# UNITED STATES PATENT AND TRADEMARK OFFICE

APPLICATION NO.	FILING DATE	FIRST NAMED INVENTOR	ATTORNEY DOCKET NO.	CONFIRMATION NO.
10/666,998	09/19/2003	Andrei Laikhter	013670-9004 US00	1003

## Office Action Summary

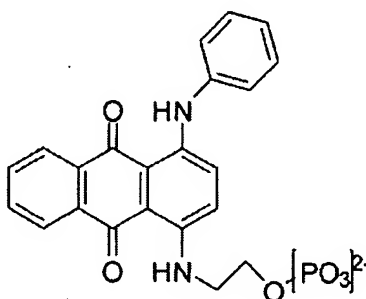
1. Applicant's election without traverse of claims 30-34 of Group II and the specie election of the anthraquinone quencher shown:
